# ADDENDUM No. 1

ITB No. 4626

## 2020 UTILITY IMPROVEMENTS

REMOVAL PLAN - 315 JOHN STREET AND JOHN STREET

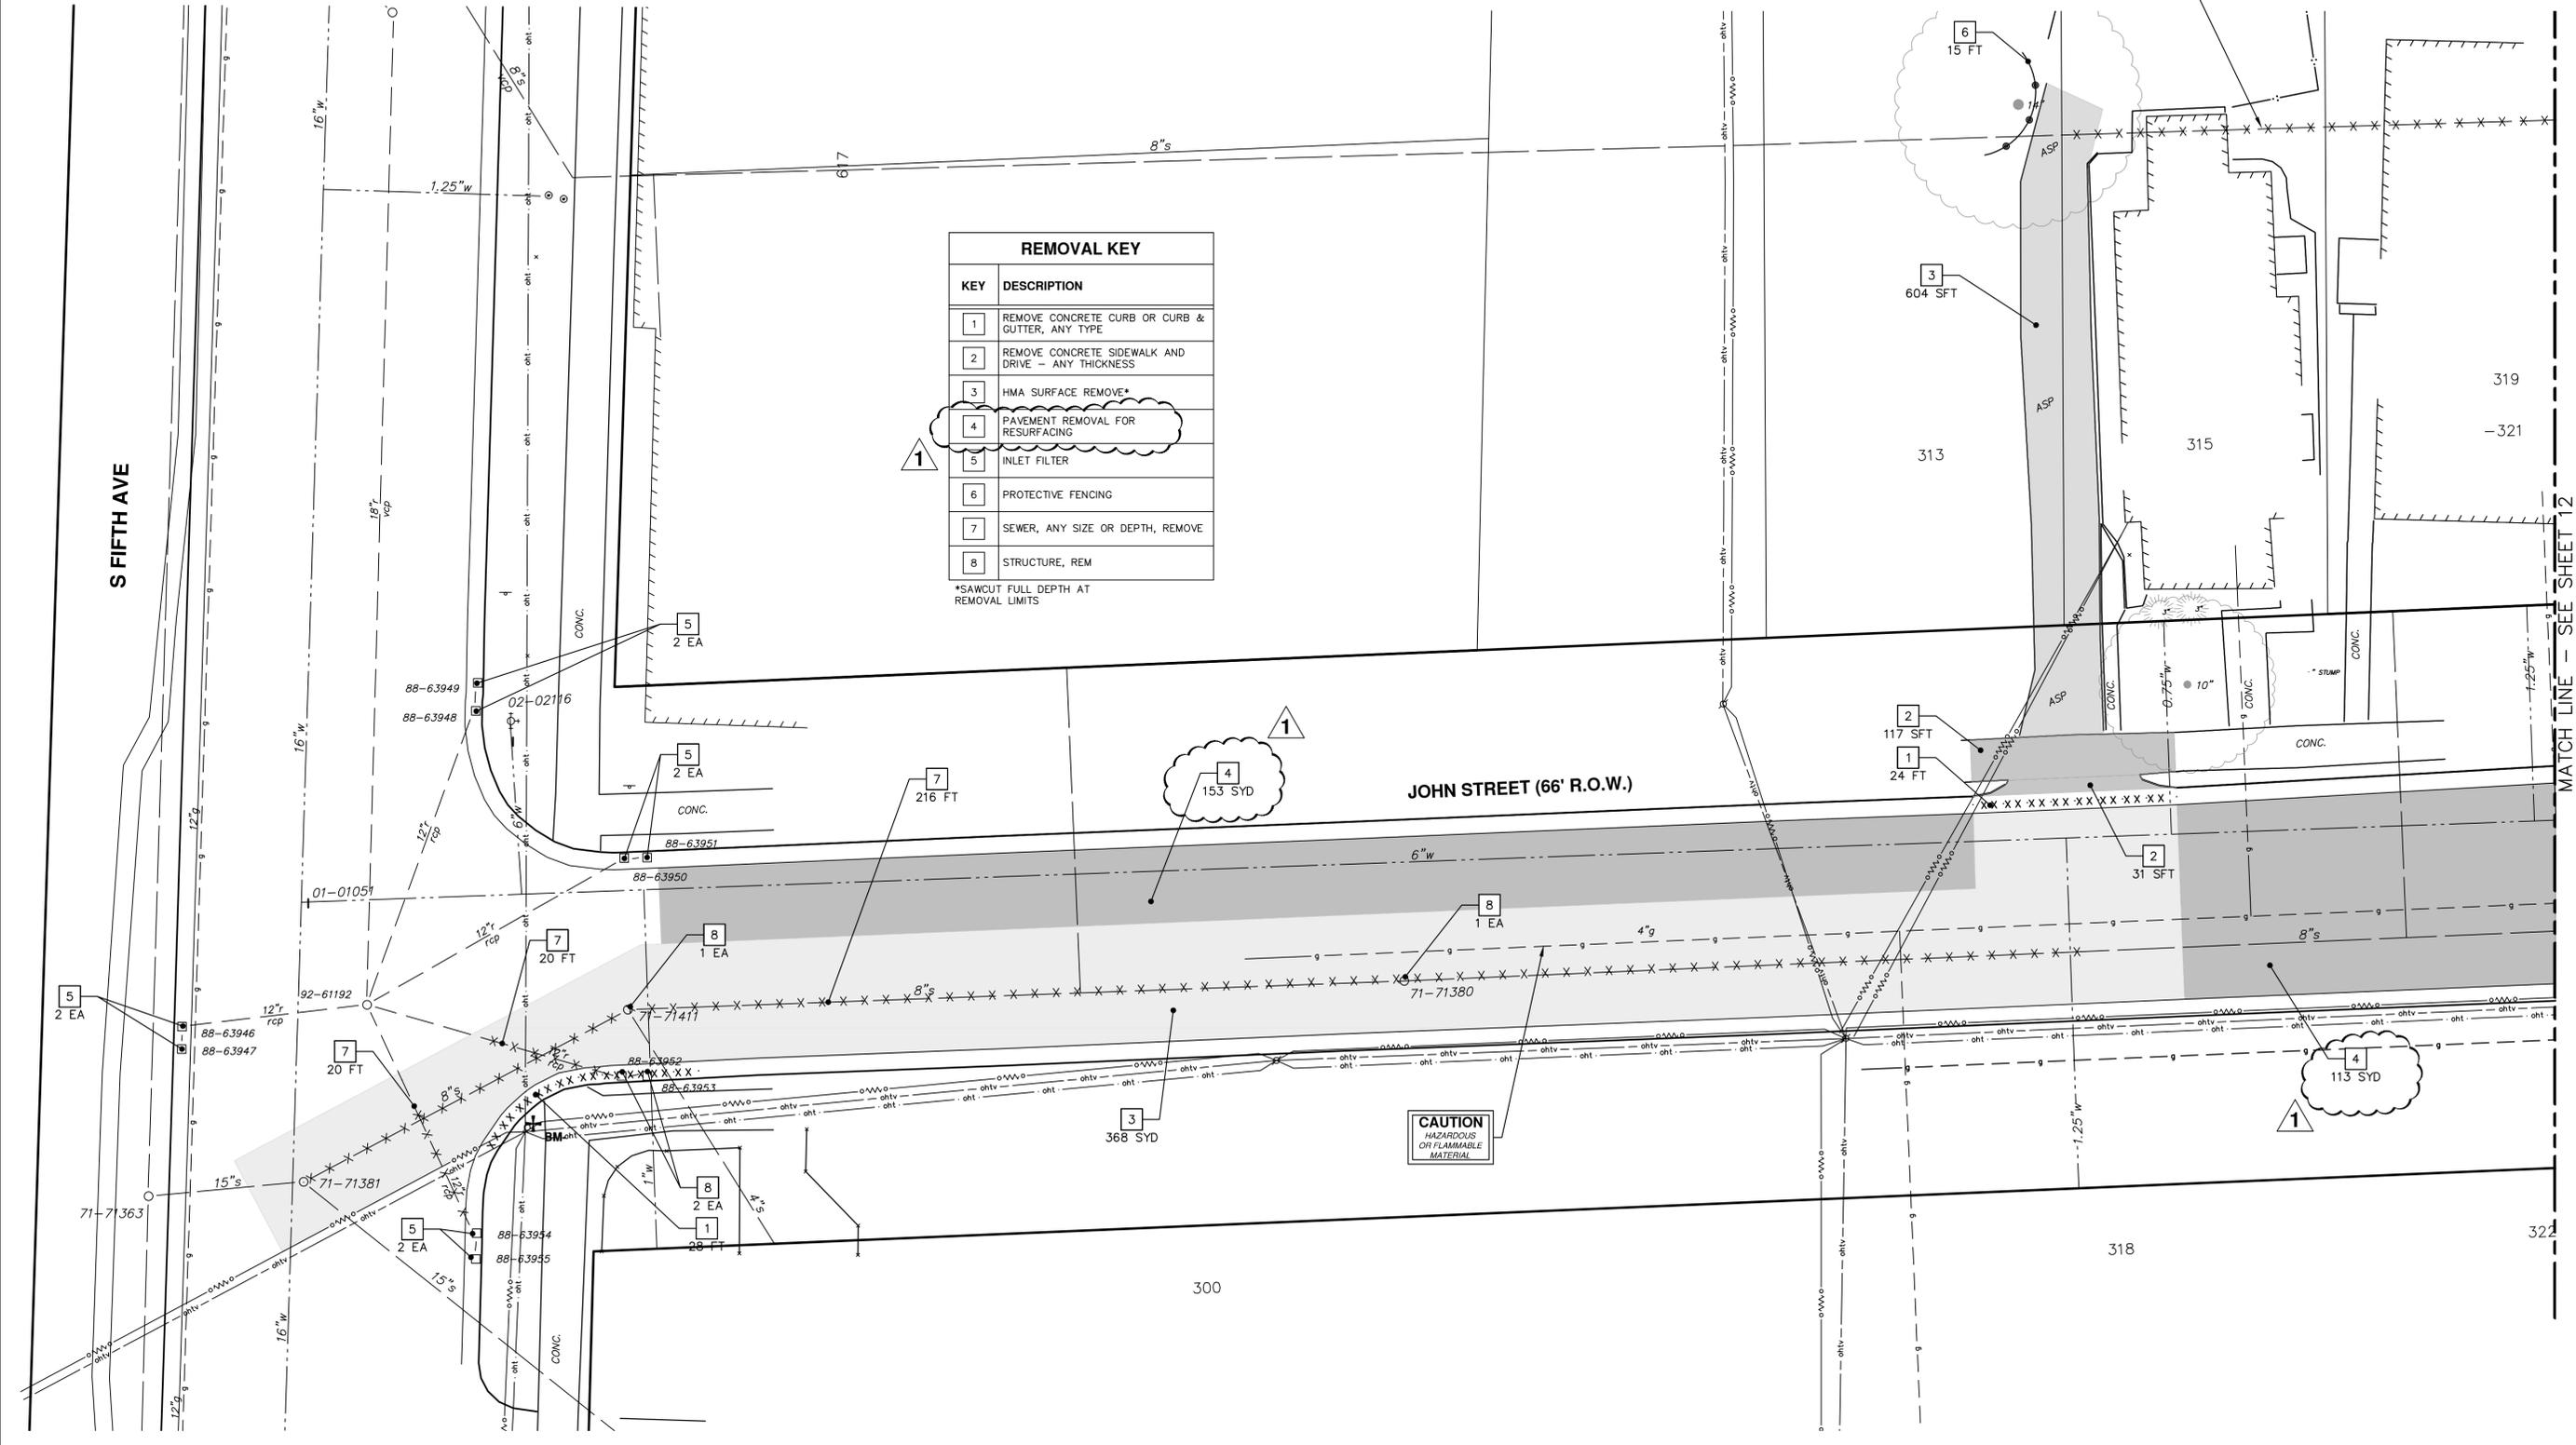
Answer 32: **John Street will have HMA removal for sewer installation, followed by HMA removal for resurfacing. This has been clarified on the plan sheets. HMA removal is all paid as item 222. There is no cold milling.**

Lateral Pipe in Huron Street Storm Sewer

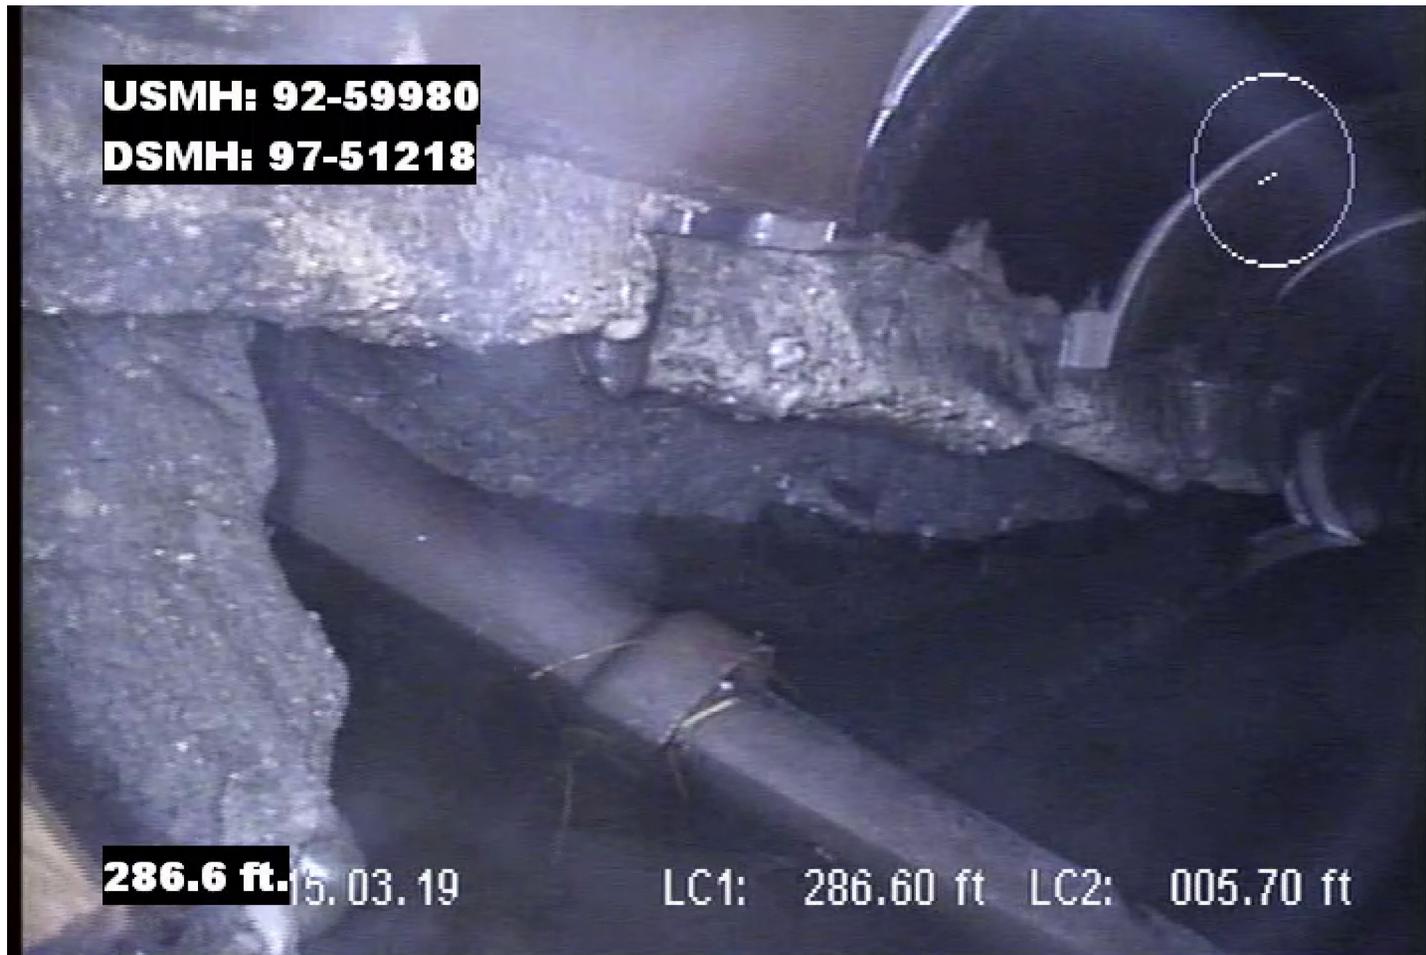
Question 34: What is the size of the abandoned lateral to be bulk headed in Huron St?

Answer 34: **It appears to be a 4-inch or 6-inch. A photograph of the lateral conflicting with the existing storm pipe is included in Addendum #1.**
